UNITED STATES PATENT AND TRADEMARK OFFICE

APPLICATION NO.	FILING DATE	FIRST NAMED INVENTOR	ATTORNEY DOCKET NO.	CONFIRMATION NO.
10/018,412	12/13/2001	Martin Hildebrand	ZAHFRI P393US	1202

Office Action Summary

DETAILED ACTION

Fig. 1

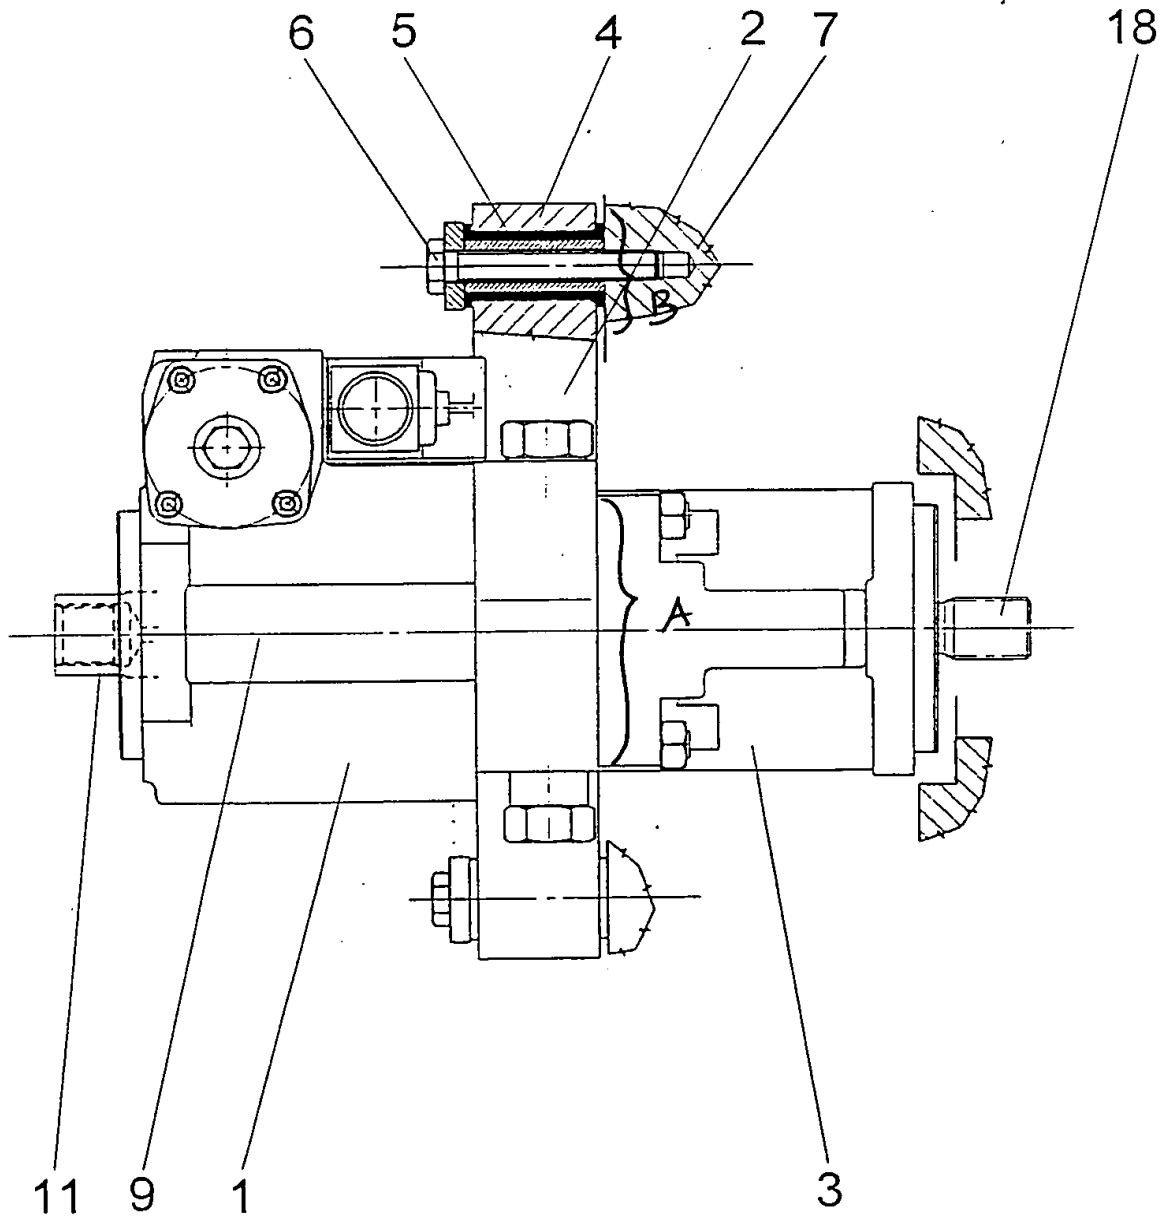
2. The drawings are objected to under 37 CFR 1.83(a). The drawings must show every feature of the invention specified in the claims. Therefore, the limitations of “*elastic damping element (5) situated only in the area in which the interconnected hydraulic pump (1) and the separate hydraulic motor (3) are connected with one another and with said transmission housing (7)*” recited in claims 1 and 20, and the limitations of “*elastic damping elements (5) are provided only at the connection point for joining the coaxially connected hydraulic pump (1) and hydraulic motor (3) with the transmission housing (7)*” recited in claim 14 must be shown or the feature(s) canceled from the claim(s). No new matter should be entered. Note that the drawings show the pump (1) connected with the motor (3) at the area (A) (see Exhibit A) via the plate (2), and the plate (2) connected with the transmission housing (7) at the area (B). There is no area of mutual connection between the pump, motor and transmission housing shown.

A proposed drawing correction or corrected drawings are required in reply to the Office action to avoid abandonment of the application. The objection to the drawings will not be held in abeyance.
